Appendix I of RNTPC
Paper No. A/YL-PS/755

**APPLICATION FOR PERMISSION
UNDER SECTION 16 OF
THE TOWN PLANNING ORDINANCE
(CAP. 131)**

(a) Proposed use(s)/development 擬議用途/發展	擬議臨時商店及服務行業 (五金雜貨零售店) 連附屬設施(為期三年) (Please illustrate the details of the proposal on a layout plan) (請用平面圖說明擬議詳情)

Temporary Shop and Services with Ancillary Office

TITLE
EXISTING DRAINAGE LAYOUT PLAN

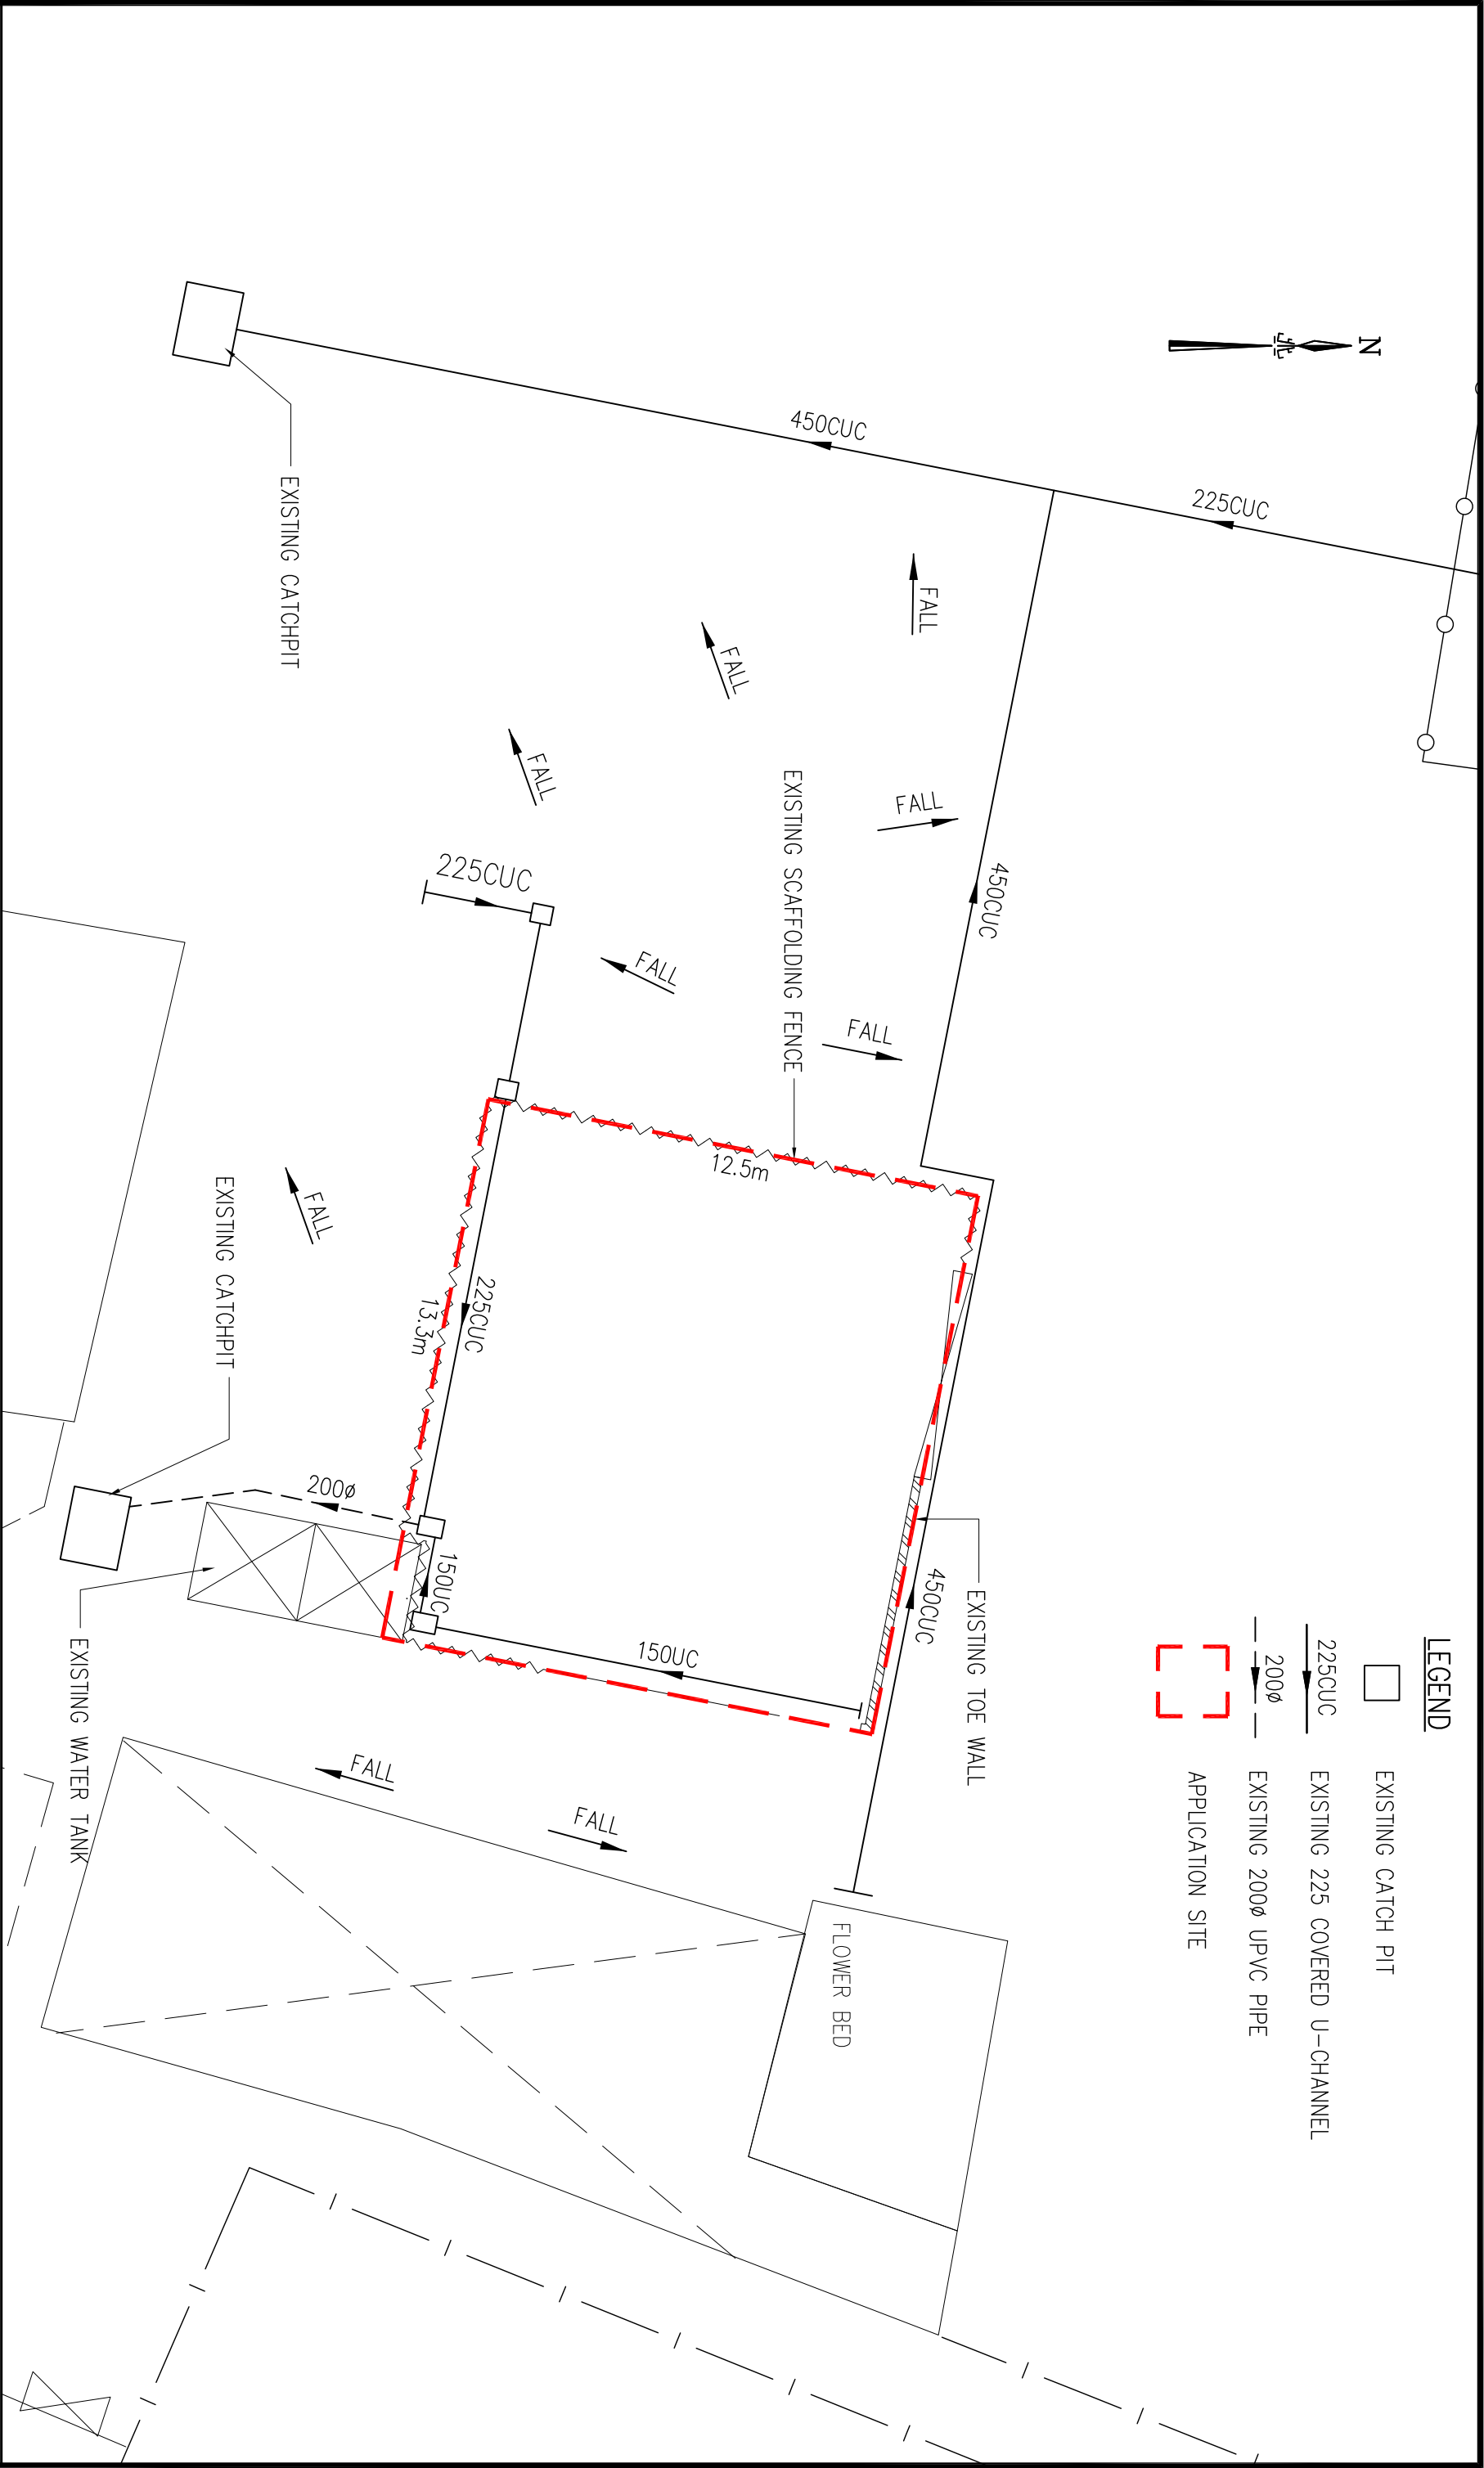
- no in-principle objection to the application from a drainage point of view;
- the submitted drainage proposal is considered acceptable; and
- it is noted that the subject planning application and the previous planning application under No. A/YL-PS/693 are submitted by the same applicant for the same use with the same site layout and development parameters. Should the Town Planning Board considers that the application be acceptable, approval condition(s) should be stipulated in the approval letter requiring the applicant to implement and maintain the proposed drainage facilities to his satisfaction.

消防裝置布局圖

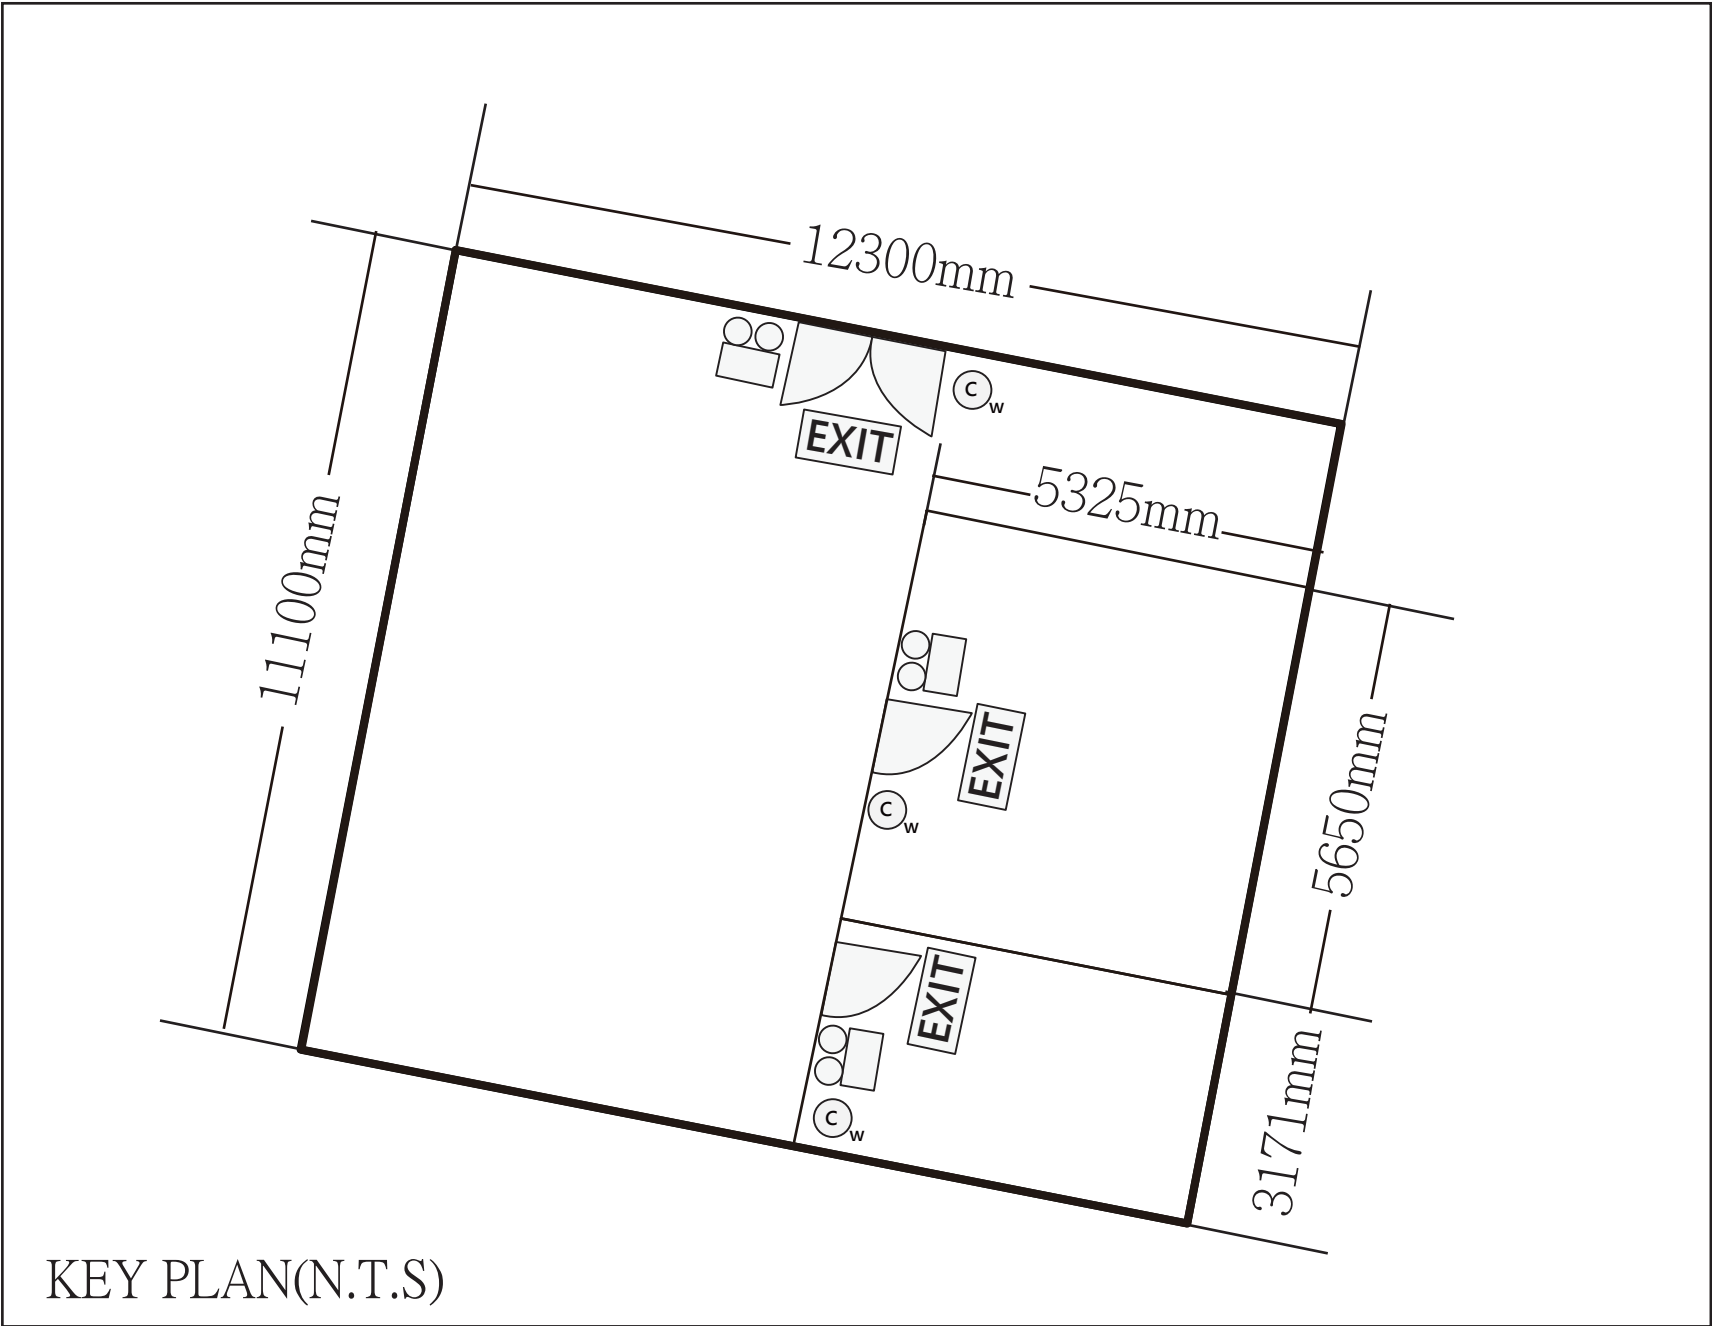
- he has no objection in principle to the proposal subject to fire service installations (FSIs) being provided to his satisfaction;
- the submitted FSIs proposal is considered acceptable; and
- in consideration of the design/nature of the proposal, FSIs are anticipated to be required. Therefore, the applicant is advised to submit relevant layout plans incorporated with the proposal FSIs to his department for approval.

- i. For enclosed structure with gross floor area not exceeding 230m², only fire extinguisher and Stand-alone Fire Detector shall be provided;
- ii. In relation to i. above, where two or more Stand-alone Fire Detectors are installed in an enclosed structure, all stand-alone detectors shall be interconnected (either wired or wirelessly) such that when one of the stand-alone fire detector is triggered, all connected Stand-alone Fire Detectors shall sound an alarm simultaneously;

- iii. The Stand-alone Fire Detector shall be provided in accordance with the "Stand-alone Fire Detector General Guidelines on Purchase, Installation & Maintenance [Sep 2011]" ;

- iv. If the applicant self-initiates the provision of emergency lighting, the standards and specification shall be in accordance with "BS 5266-1:2016, BS EN 1838:2013 and the FSD Circular Letter No. 4/2021" ; and

- v. If the applicant self-initiates the provision of directional and exit signs, the standards and specification shall be in accordance with "BS 5266-1:2016 and the FSD Circular Letter No. 5/2008" .
